TENNESSEE VALLEY AUTHORITY

BROWNS FERRY NUCLEAR PLANT, UNIT 2

AMENDMENT TO FACILITY OPERATING LICENSE

Amendment No. 257
License No. DPR-52

Figure 3.4.9-1
Pressure/Temperature Limits

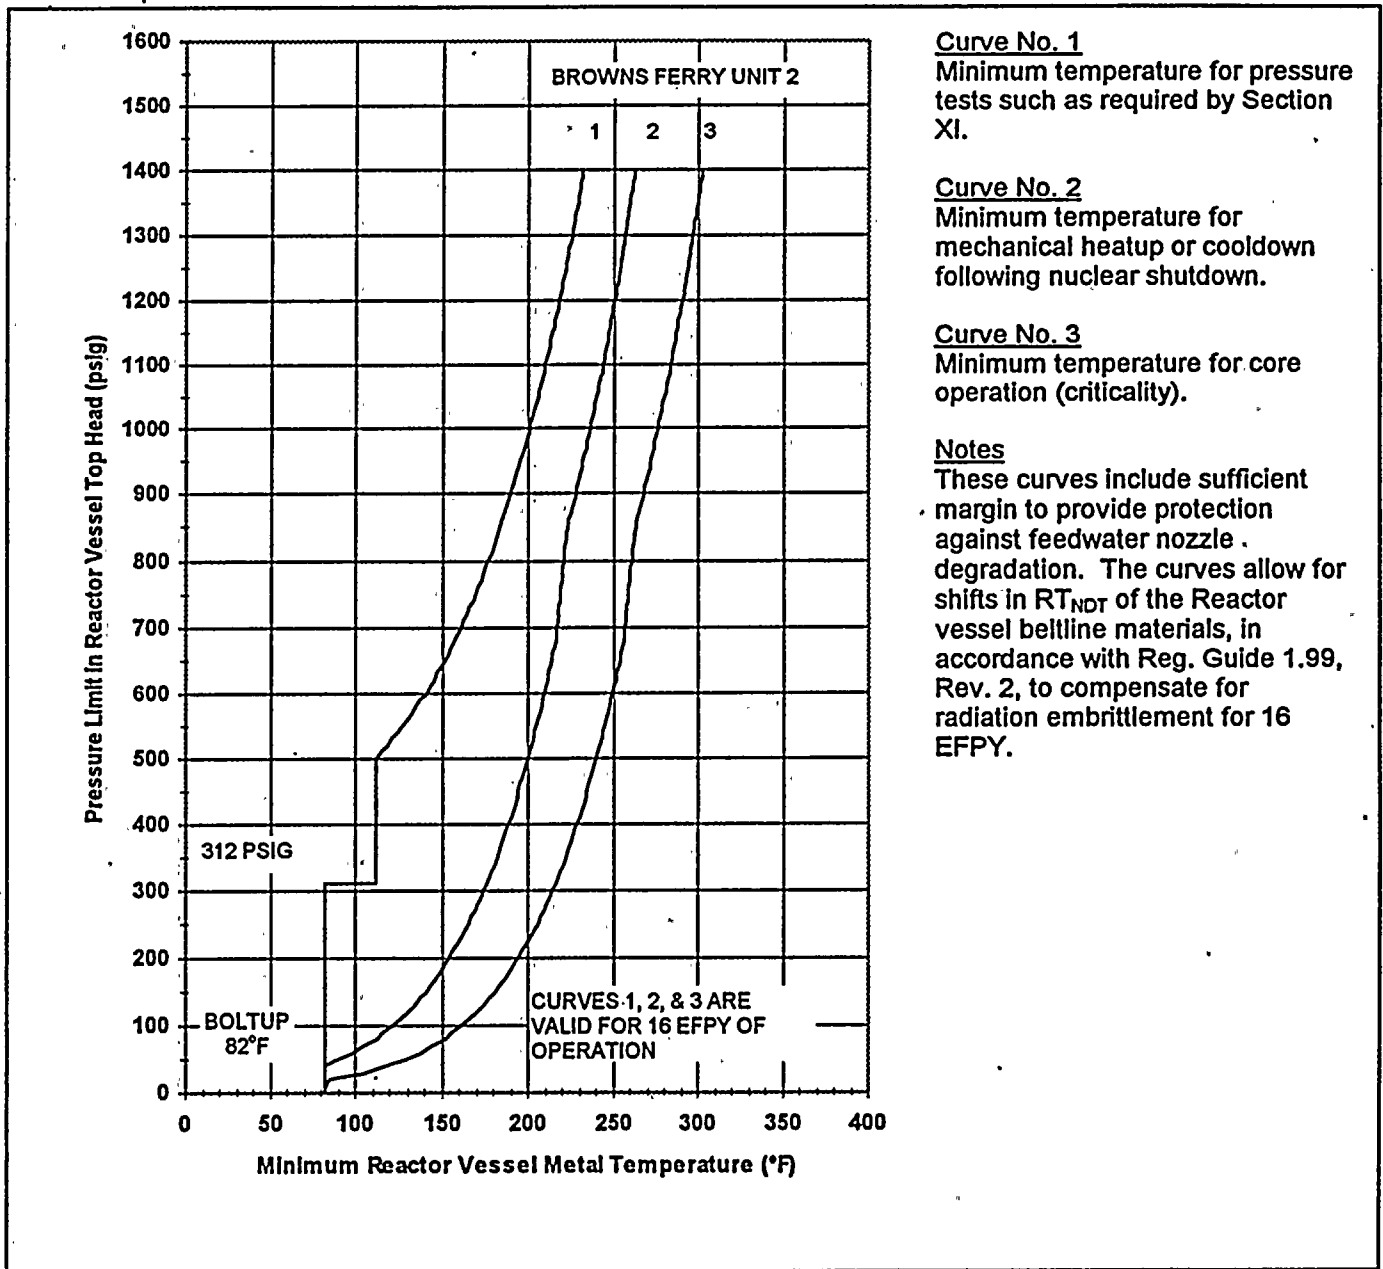
Revise the Appendix A Technical Specifications by removing the pages identified below and inserting the enclosed pages. The revised pages are identified by the captioned amendment number and contain marginal lines indicating the area of change.

Figure 3.4.9-1
Pressure/Temperature Limits

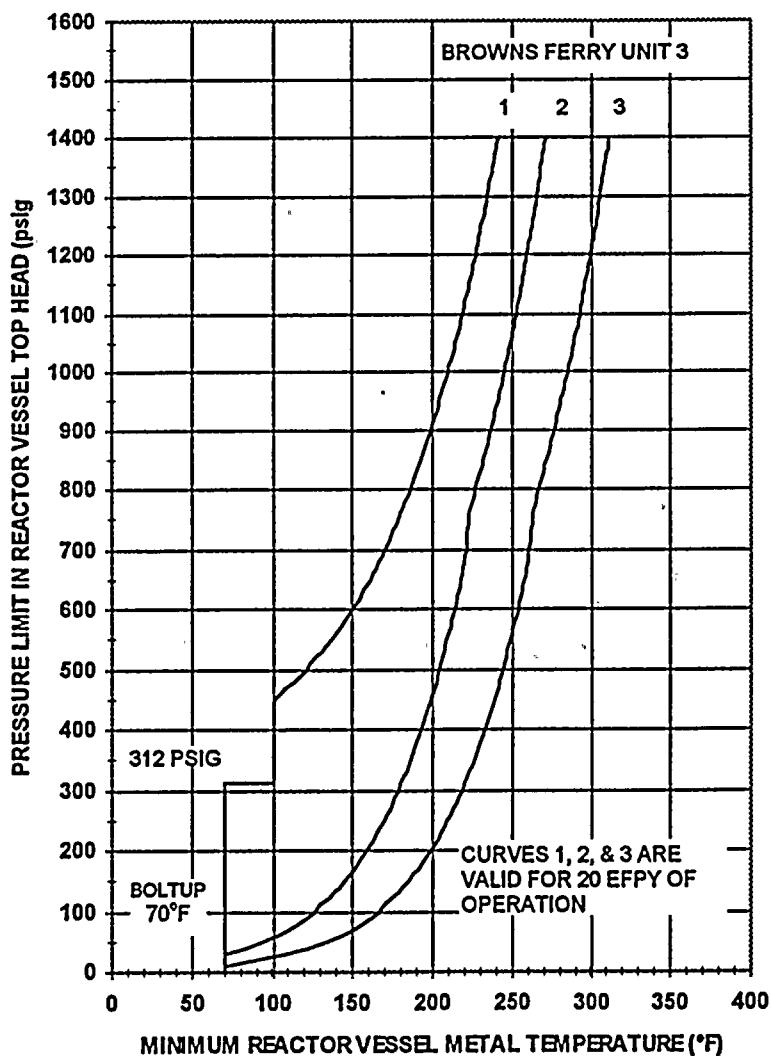
Revise the Appendix A Technical Specifications by removing the pages identified below and inserting the enclosed pages. The revised pages are identified by the captioned amendment number and contain marginal lines indicating the area of change.

Curve No. 1
Minimum temperature for pressure tests such as required by Section XI.

Curve No. 2
Minimum temperature for mechanical heatup or cooldown following nuclear shutdown.

Curve No. 3
Minimum temperature for core operation (criticality).

Notes
These curves include sufficient margin to provide protection against feedwater nozzle degradation. The curves allow for shifts in RT_{NDT} of the Reactor vessel beltline materials, in accordance with Reg. Guide 1.99, Rev. 2, to compensate for radiation embrittlement for 20 EFPY.
